# CITY OF ALBUQUERQUE

RE: **Amerstone Assisted Living**  
**7503 Central Ave NE**  
**Grading Plan**  
**Engineer's Stamp Date: 1/3/18**  
**Hydrology File: K19D150**

Re: Amerstone Assisted Living  
Grading and Drainage Plan  
**Hydrology File: K19D150**

PROJECT TITLE	AMERISTONE ASSISTED LIVING ALBUQUERQUE, NEW MEXICO
SHEET TITLE	GRADING AND DRAINAGE PLAN
SHEET	C1

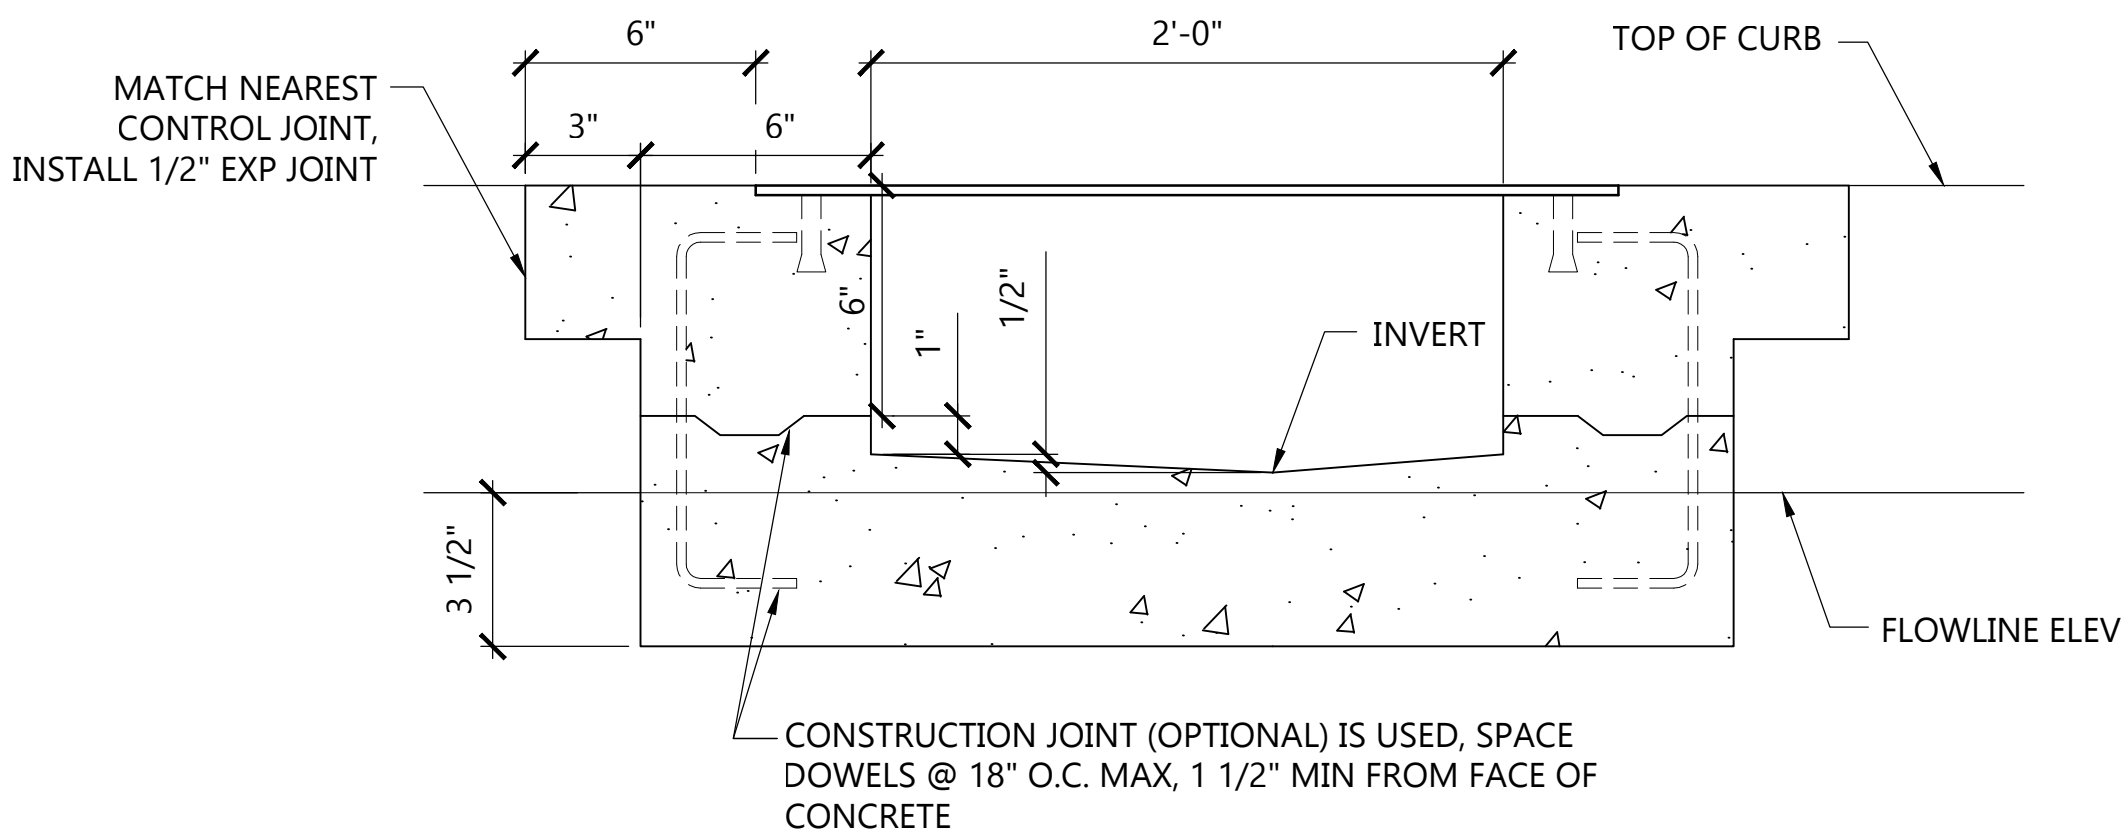
- 1) The first flush pond must be sited where it will receive all runoff from the impervious areas. If runoff from impervious areas cannot be captured on-site, this bypass volume must be calculated and stated on the plan.

**A Fee-in-Lieu of \$8/CF x 70CF = \$560 will be paid.**
- 2) The site qualifies as redeveloped and is only required to retain runoff from the 80<sup>th</sup> percentile storm (Vol. = 0.26<sup>th</sup>\*Imp.Area).

**The notarized Private Facility Drainage Covenant and recording fee has been turned in as part of the resubmittal.**
- 3) This site discharges to a floodplain in Espanola and Chico; no increase in runoff from the existing condition can be authorized. The plan currently demonstrates this, and future resubmittals must continue to do so as well.

**The Grading Plan has been revised to show the bypass volume of 70 CF.**
- 1) Payment of Fee-in-Lieu will be required for the first flush bypass volume at the rate of \$8/CF.

**The Drainage Calculations have been revised to show 293 CF of required runoff to be retained.**
- 2) A Private Facility Drainage Covenant is required for the first flush pond. The original notarized forms, exhibits, and recording fee (\$25, payable to City of Albuquerque) must be turned into DRC (4<sup>th</sup>, Plaza del Sol) for routing. Please contact Charlotte LaBadie ([clabadie@cabq.gov](mailto:clabadie@cabq.gov), 924-3996) or Madeline Carruthers ([mtafoya@cabq.gov](mailto:mtafoya@cabq.gov), 924-3997) regarding the routing and recording process for covenants.

**Acknowledged.**
